Deception

The Response to Submissions document is deceptive in a number of ways:

Millers Point Community Residents Action Group

Views to Millers Point Conservation Area

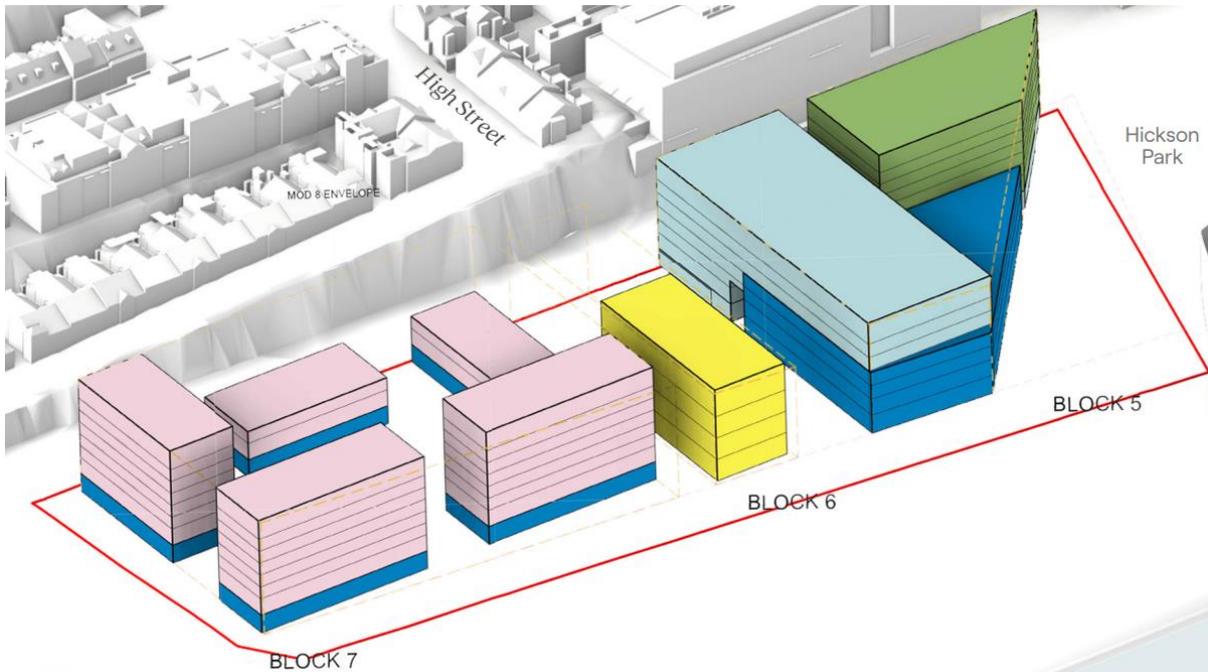
Note the use of the term “optimise” rather than “retain” which is in the planning controls:

- 40. The EDH proposal will retain the ability to appreciate the Millers Point headland and the roofscape of terrace houses throughout Millers Point when viewed from public spaces on opposite foreshores.
